Updating the Barton Springs Groundwater Availability Model

Barton Springs Segment of the Edwards Aquifer GAM
2nd Stakeholder Advisory Forum
January 8, 2009
Austin, Texas

**Second Barton Springs Segment of the Edwards Aquifer Groundwater
Availability Model (GAM) Stakeholder Advisory Forum
(SAF)**

**Barton Springs Edwards Aquifer Conservation District (BSEACD)
Office
Manchaca, Texas**

Extended Model Domain and Recharge

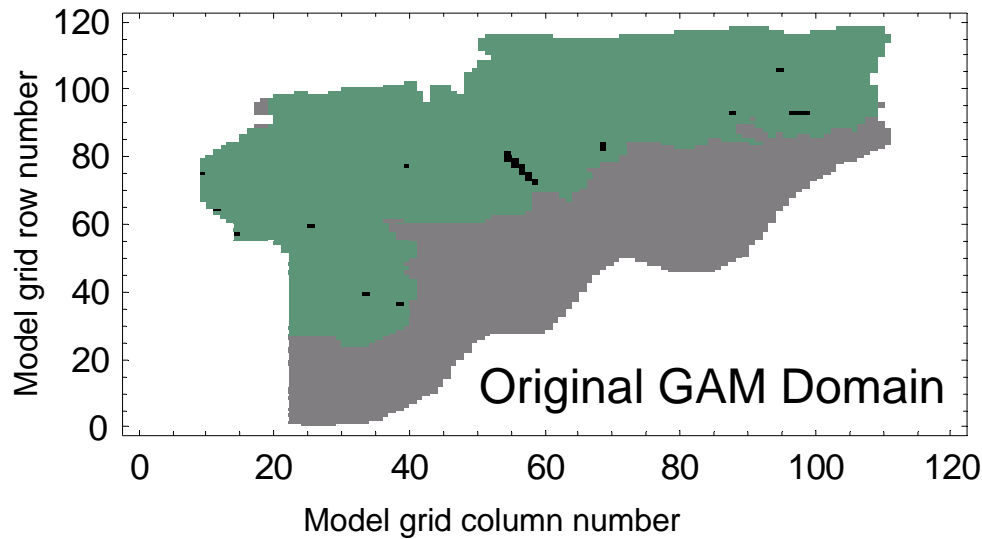
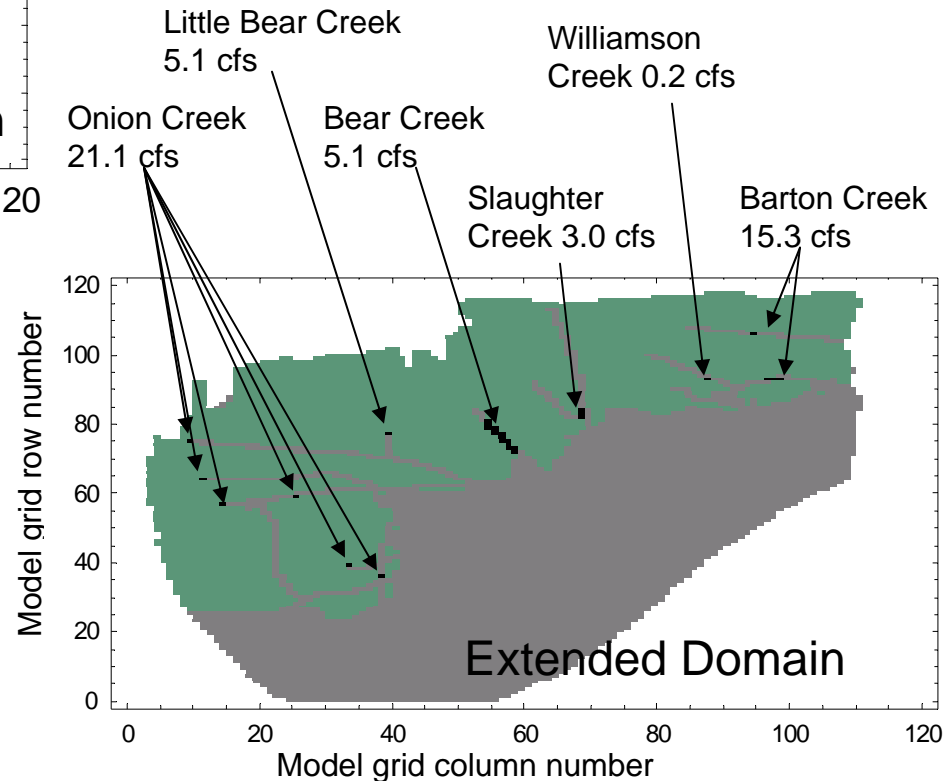
Q. What is the total recharge?

A. Approximately 60 cfs for steady-state conditions.

Conduit Network in MODFLOW-DCM

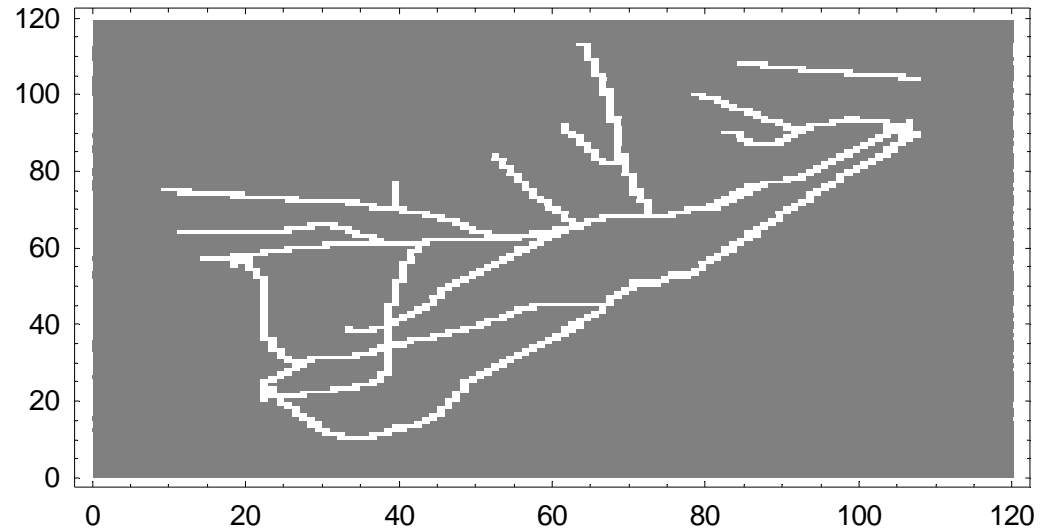
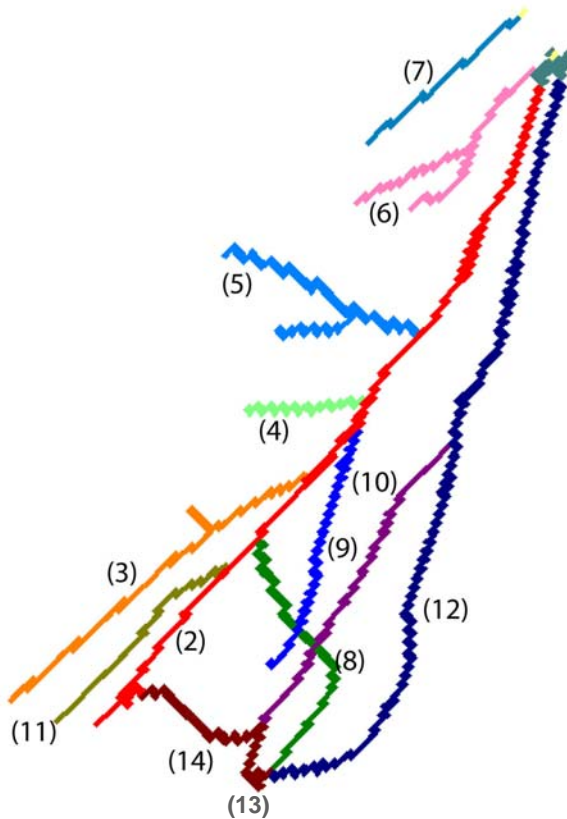
Q: Are conduits connected where they cross?

Q. Are velocities of conduits different?

A: Yes, the conduit network in the DCM model is limited to one layer.

A. Yes. Velocities are dependent on the hydraulic properties assigned to the conduits.

Recharge as a Function of Precipitation

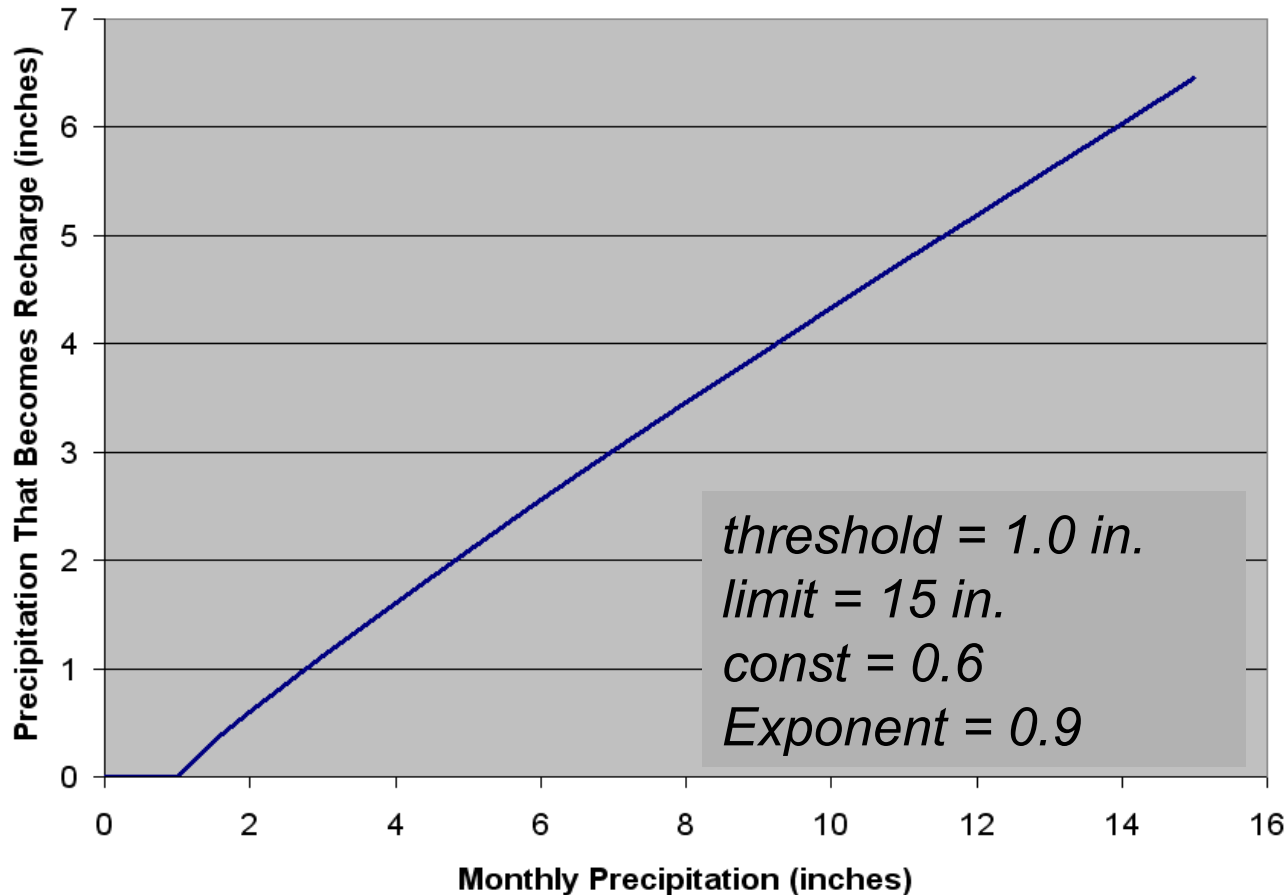
Q. Were there differences during summer and winter in the fraction of precipitation that becomes recharge?

Q. Was any limit imposed on recharge?

A. No. The recharge function does not account for seasonal changes (i.e., winter versus summer recharge). In the transient simulations, recharge is varied over time.

A. No, setting a limit on the fraction of precipitation that becomes recharge in the recharge algorithm was assessed in the transient simulations and found to not have a noticeable effect on the calibration.

Transient Calibration

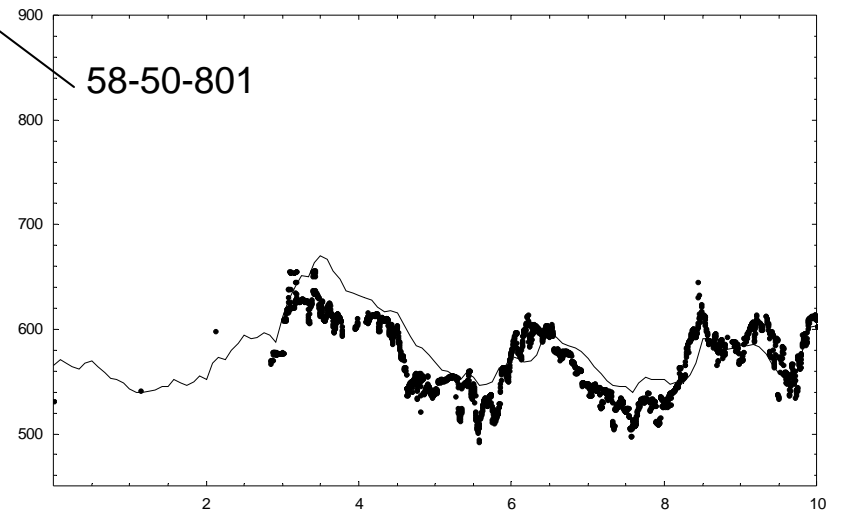
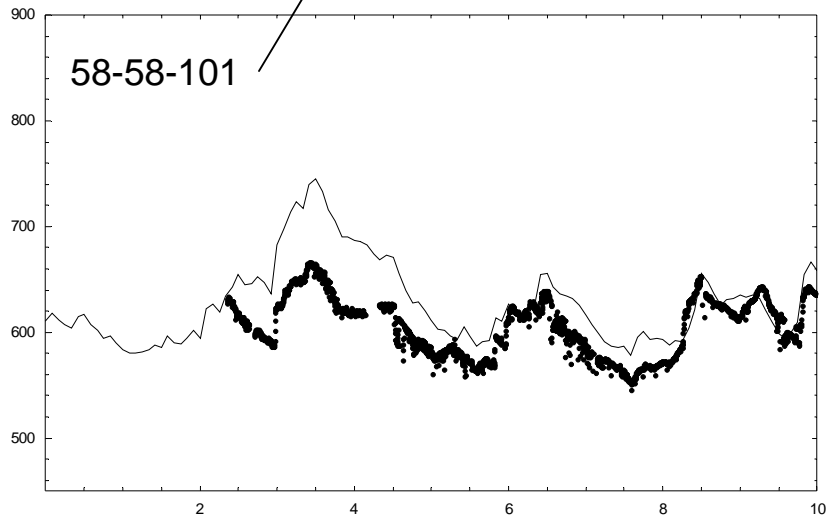
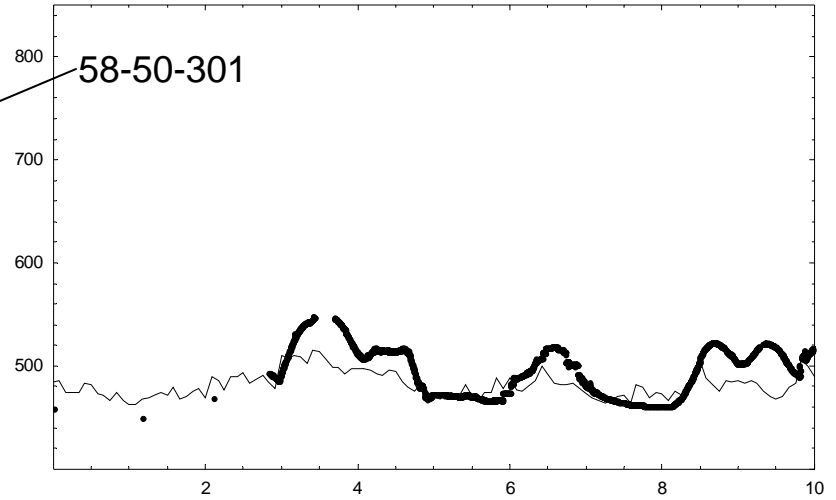
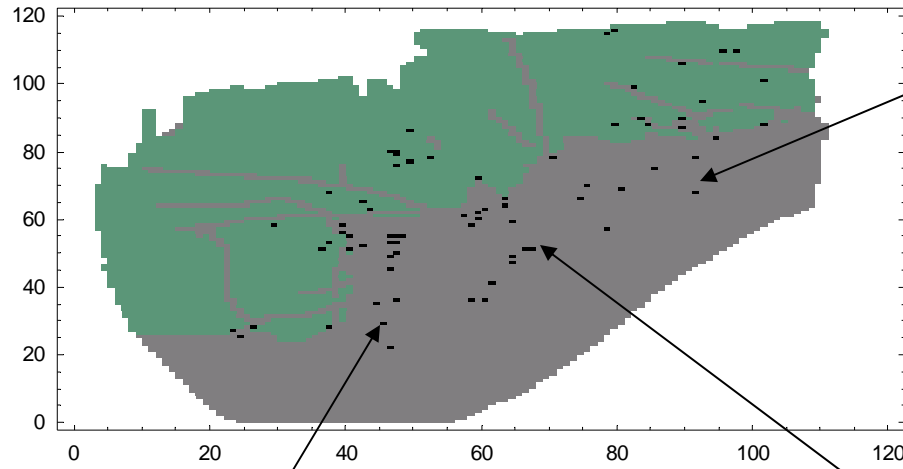
Comment: Including a flow restriction in downstream conduits might remove some of the peaks in the simulations.

Comment: Including a more complex storage term could also remove the peaks in the simulations.

Q. How close was the simulation to the actual low flow discharge values?

Comment: This comparison should be included in the final report to be able to justify the new GAM model.

A. We don't have that number available, but will include it in the final report.
